ENGINE - LP COMPRESSOR - PROVIDE A NEW FAN CASE-TO-MAIN GEARBOX ASSEMBLY MATING SEAL RING - CATEGORY CODE 6 - MOD.ENG-72-0212

V2500-ENG-72-0212

Before and After Alteration of Sealing Ring  
Fig.1

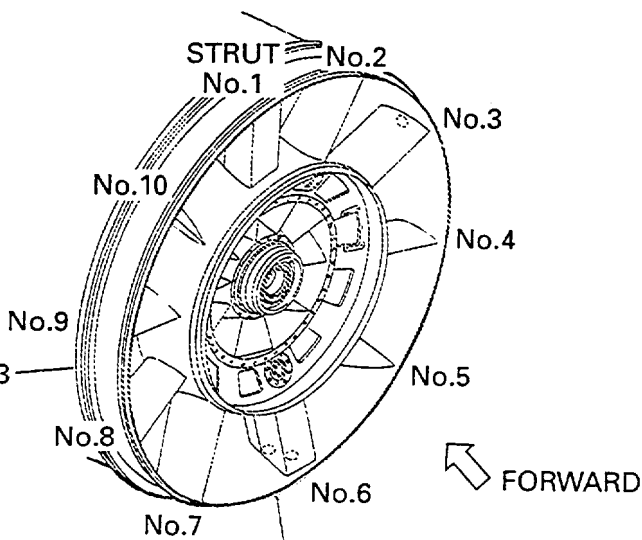
Width of the Sealing Ring on the Oil Seal Tube is decreased. See Figure 1.

SEALING RING  
REMOVE 5A2138 AND  
INSTALL 5A1641

Install the 5A1641, Sealing Ring by the approved procedure given in Reference (1), Chapter/Section 72-32-00, Assembly-11.
